**MONTEREY PENINSULA WATER MANAGEMENT DISTRICT**

**ADDENDUM NO. 1  
TO  
CONTRACT DOCUMENTS**

**For Construction  
Of  
SANTA MARGARITA WATER TREATMENT FACILITY PROJECT**

A101

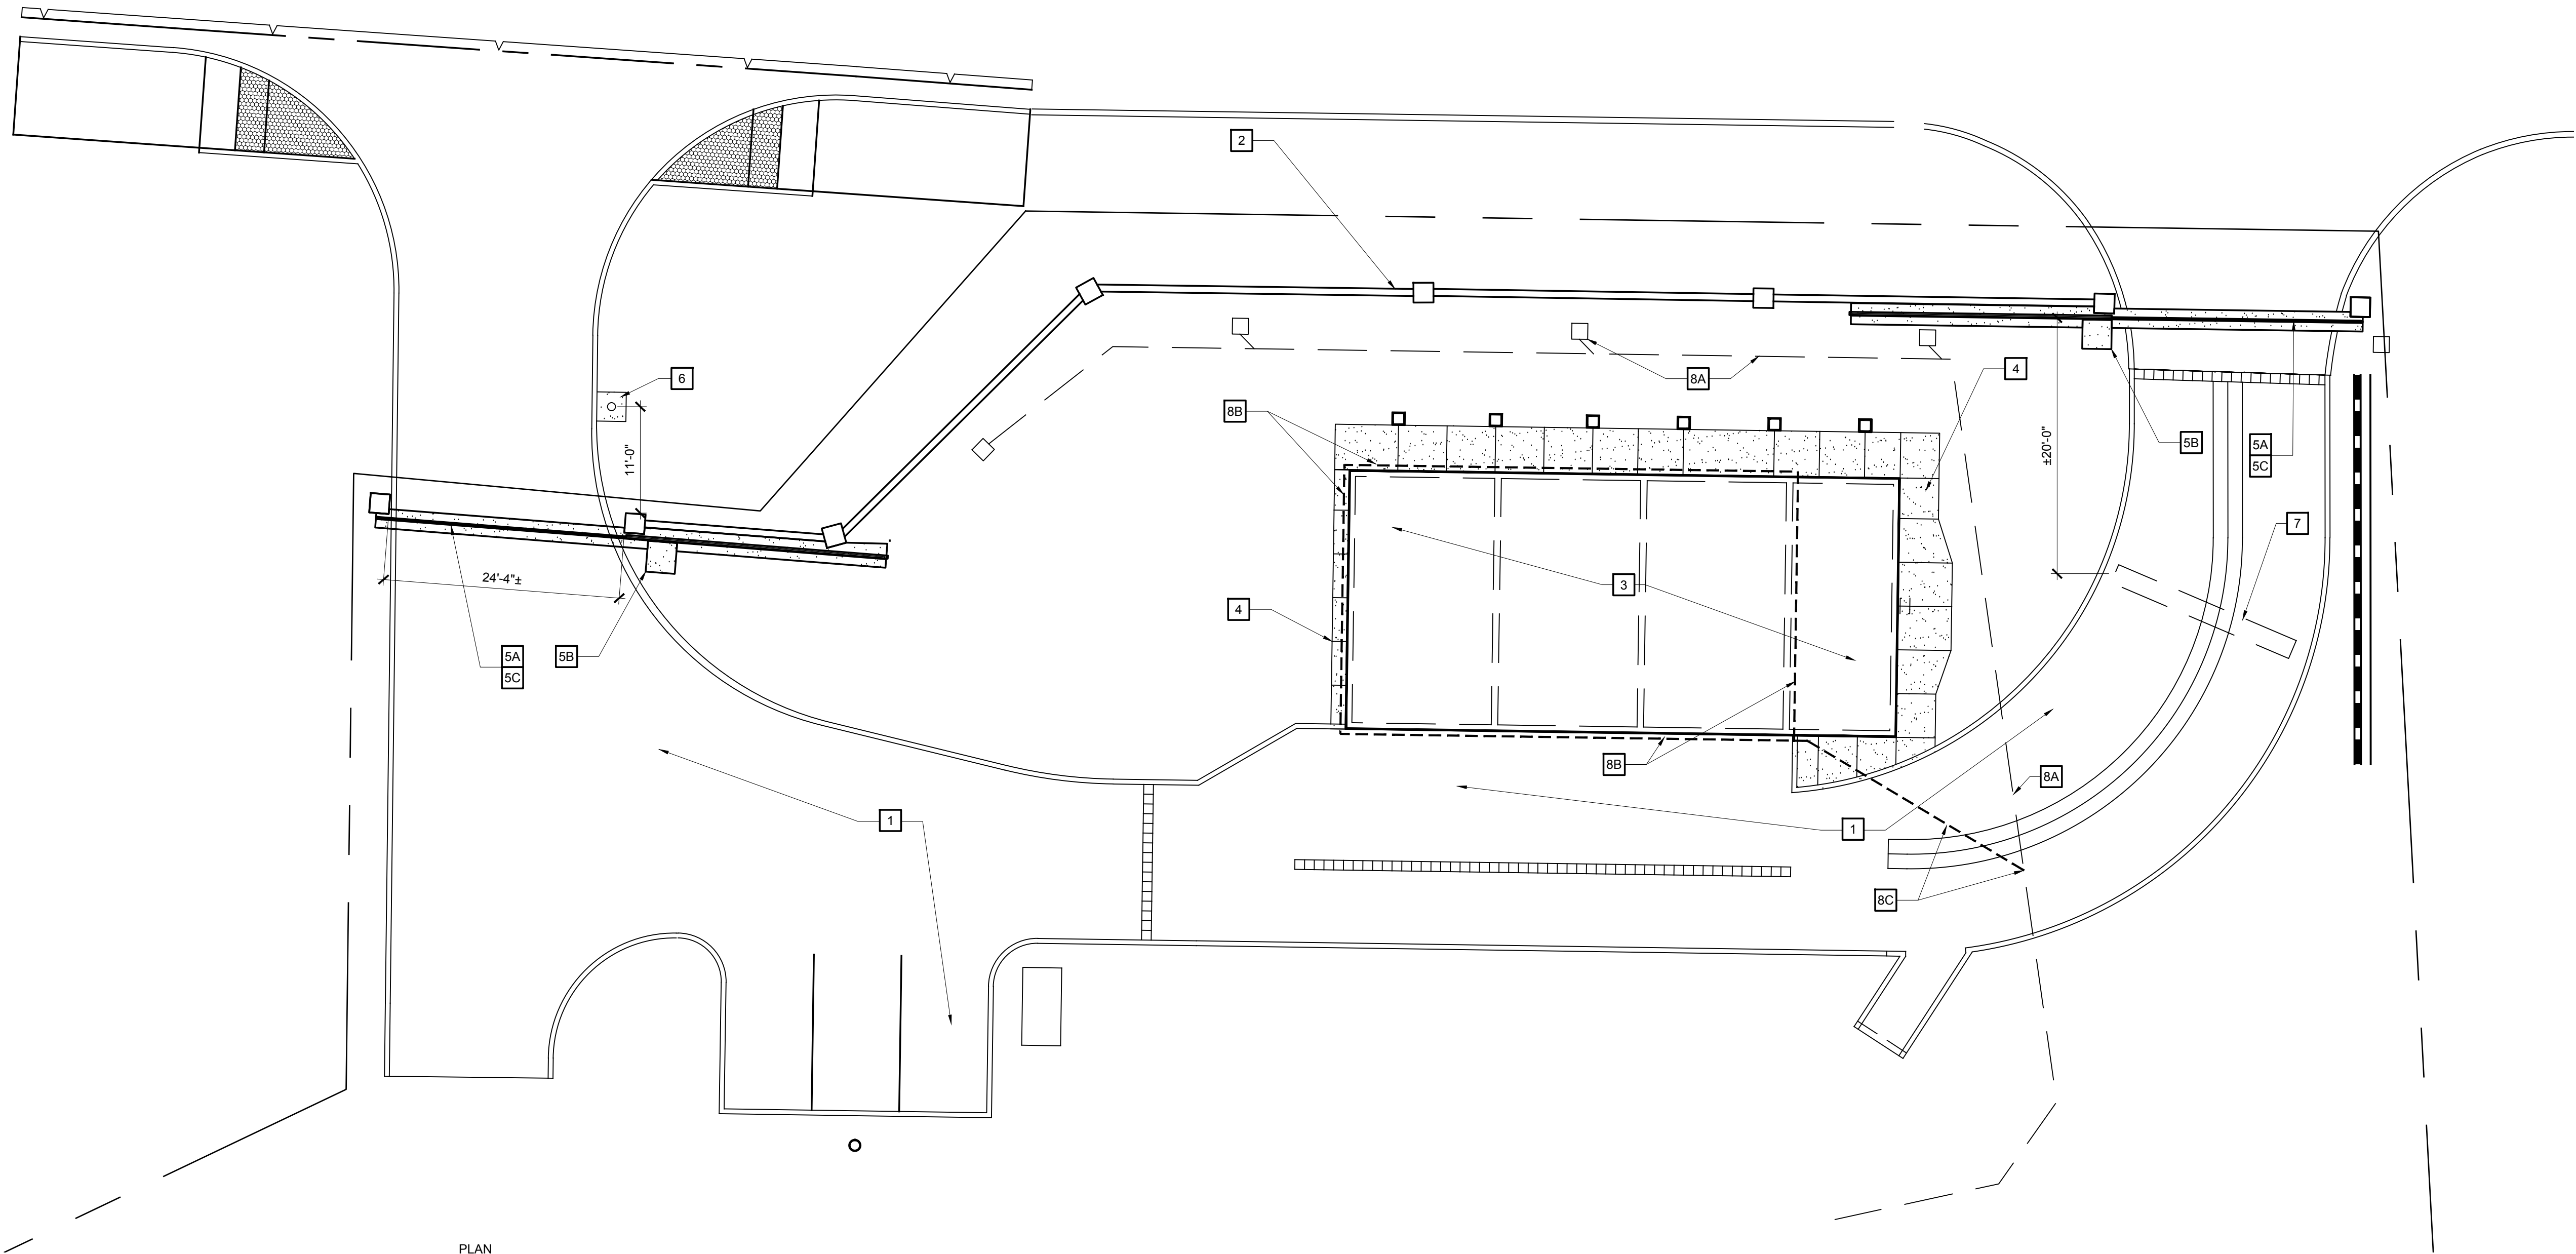
Construction Plan Drawing A101.

Sheet has been revised to show where the building underdrain ties into the existing drains on site.

Delete old Sheet A101 in its entirety.

Add the Construction Plan A101, noted as "Bid Addendum #1, 8-27-2019" in revision block, included in this Addendum 1 as Exhibit B.
